RICKEN ACRES

RE: SUB 2003-45 -- Revised One-Step Final Plat of Ricken Acres Addition

**STAFF REPORT  
(Revised One-Step Final Plat)**

**CASE NUMBER:** SUB 2003-45 -- RICKEN ACRES ADDITION

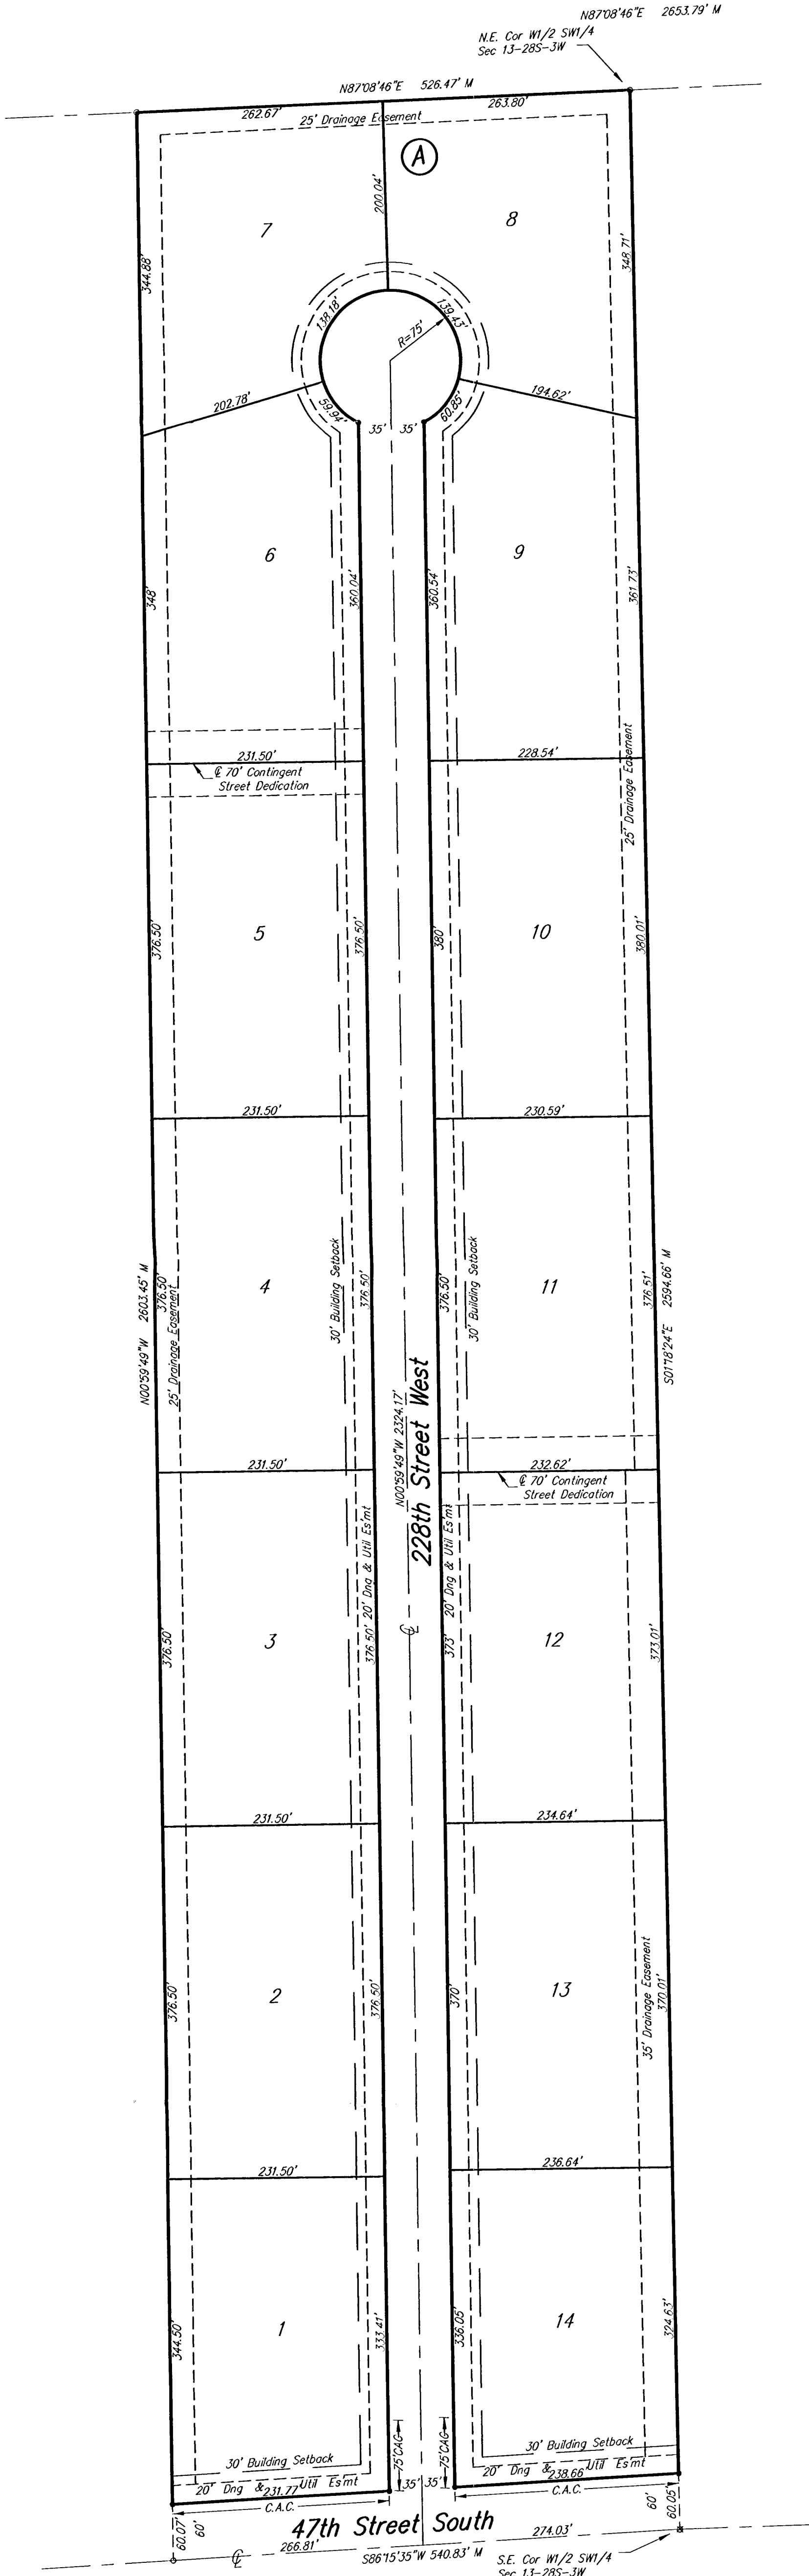
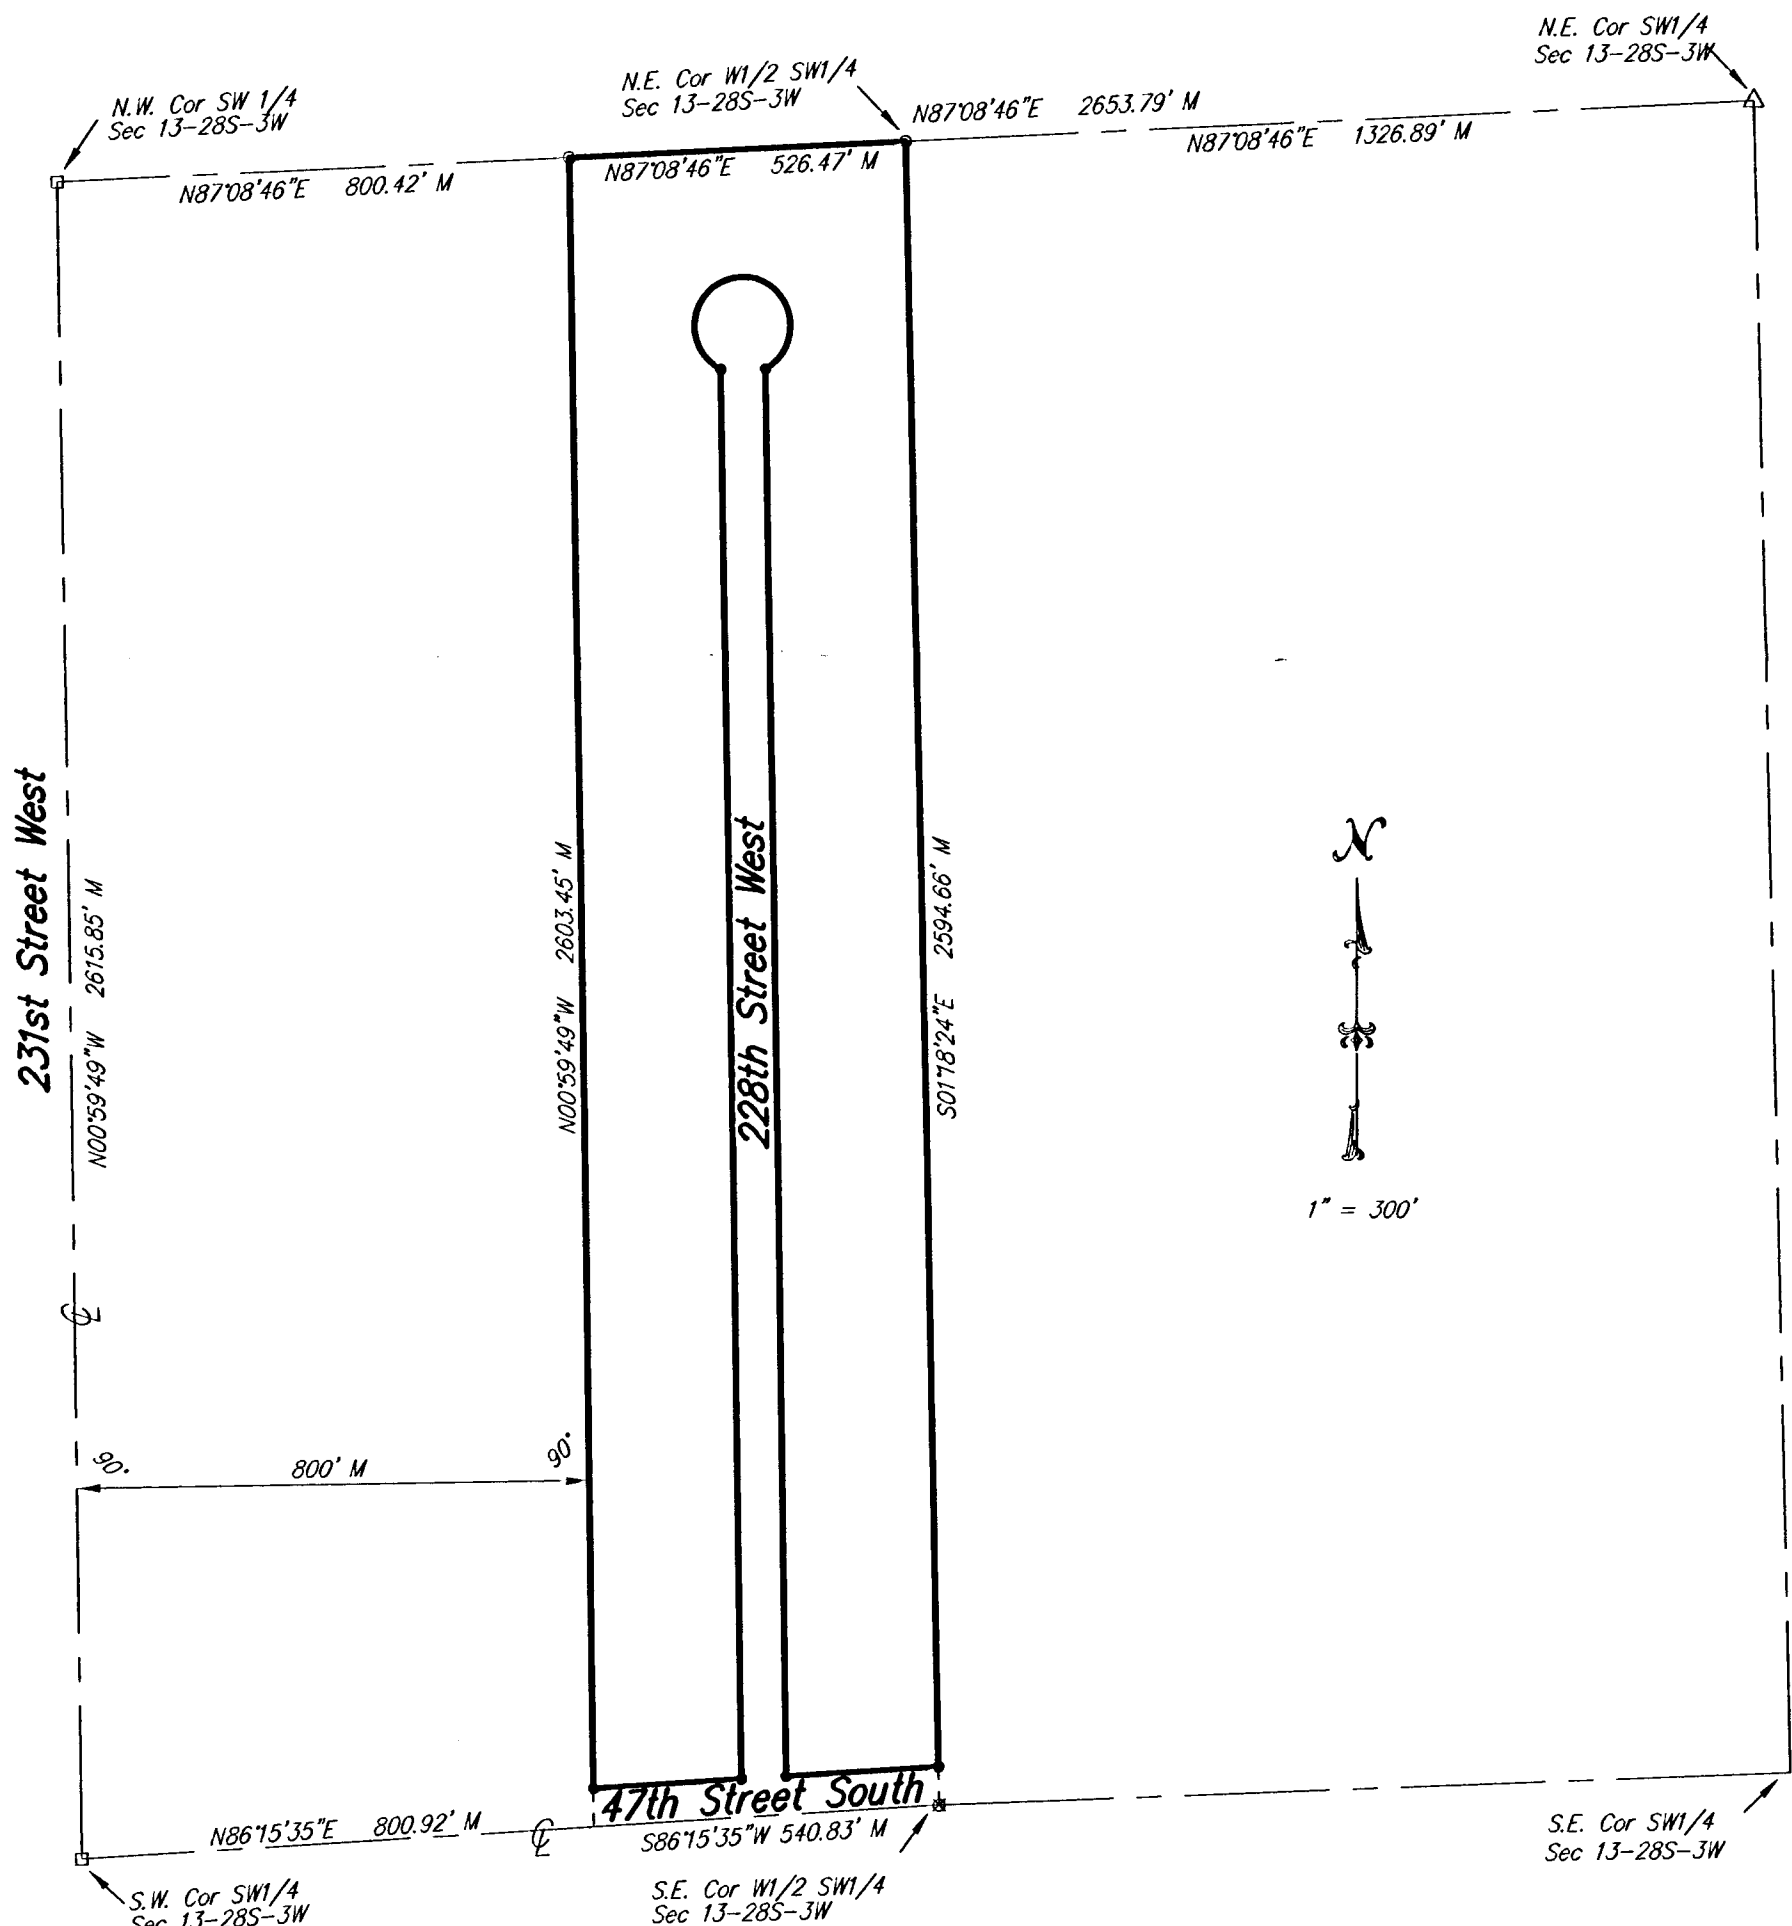
- E. **County Engineering** needs to comment on the status of the applicant's drainage plan. **A drainage plan is needed that addresses terraces and offsite drainage coming into plat from the east.**

- F. The applicant shall guarantee the installation of the proposed street to the 36-ft rock suburban street standard.
- G. Lots 1, 7, 8 and 14 contain less than the required 2-acre minimum lot size. A zoning adjustment will need to be approved for these lots. This adjustment should be submitted after the MAPC approval.

- I. The Applicant has provided a 70-ft contingent dedication of street right-of-way extending to the east line and west line of the plat in order to provide potential street connections to adjoining properties. MAPD recommends that the contingent street dedication to the west is relocated to the north between Lots 5 and 6.

- J. The MAPC signature block needs to reference "John L. Schlegel, Secretary".
- K. The County Fire Department/GIS needs to comment on the plat's street names. The street name shall be revised to "228<sup>th</sup> St W.

- M. The plat's text shall include language that a drainage plan has been developed for the plat and that all drainage easements, rights-of-way, or reserves shall remain at established grades or as modified with the approval of the applicable City or County Engineer, and unobstructed to allow for the conveyance of stormwater.
